Ref: NJA/24/247

MINOR MATERIAL AMENDMENT APPLICATION UNDER S73
SUPPORTING LETTER / STATEMENT

Applicant: **Mr J Smith**
Proposal: **Minor material amendment relating to application DC/25/0115 to vary the approved plans under condition no.1 – construction of dwelling and detached garage/storage building. Creation of new vehicle access from Parthings Lane**
Site: **The Hermitage, Tower Hill, Horsham, West Sussex, RH13 0JS**

The Hermitage, Parthings Lane, Tower Hill, Horsham RH13 0JS	Proposed New Dwelling Floor Plans	Scale 1:100 @A3 Nov 2024 Drawing No: HER/ORC/03 Rev B

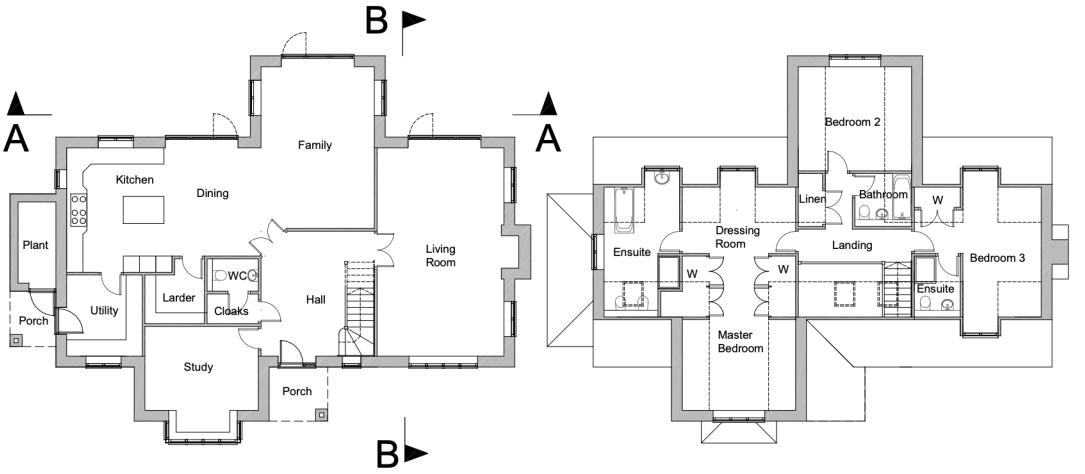
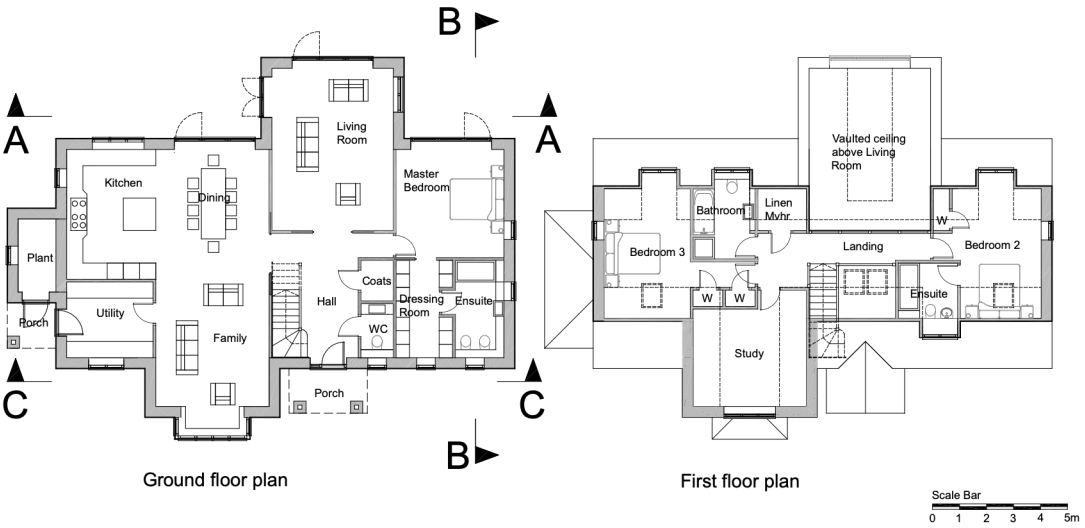
Rev:B New revision for MMA 01/11/26
Rev:A Floor plans revised to relocate Master Bedroom Suite to ground floor, study to first floor and add vaulted ceiling to Living Room 25/09/26

Floor plans above as proposed. Master bedroom suite relocated to ground floor, living room relocated and study moved to first floor. Kitchen/dining/family area replanned and porch centralised on front door. Vaulted ceiling to living room and chimney omitted. Proposed elevations comparison (see application drawings for true to scale):

The Hermitage, Parthings Lane, Tower Hill, Horsham RH13 0JS	Proposed New Dwelling Elevations	Scale 1:100 @A3 Nov 2024
		Drawing No: HER/ORC/04 Rev:B

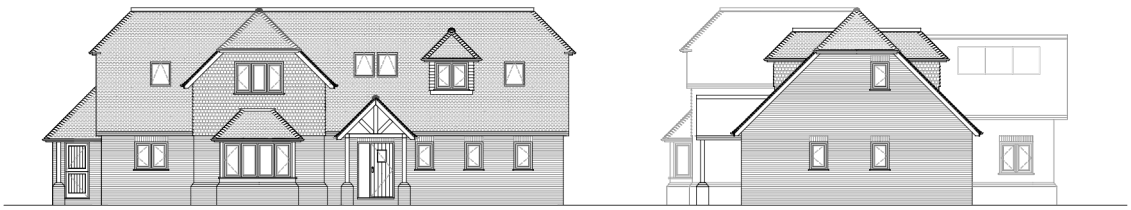
Rev:B New revision for MMA 01/11/26
Rev:A Elevations updated to revised floor plans 25/09/26

Elevations above as proposed. Elevations reconfigured to suit proposed floor plans, reduced rear projection accommodates relocated living room with vaulted ceiling, roof porch centralised on front door, chimney omitted.
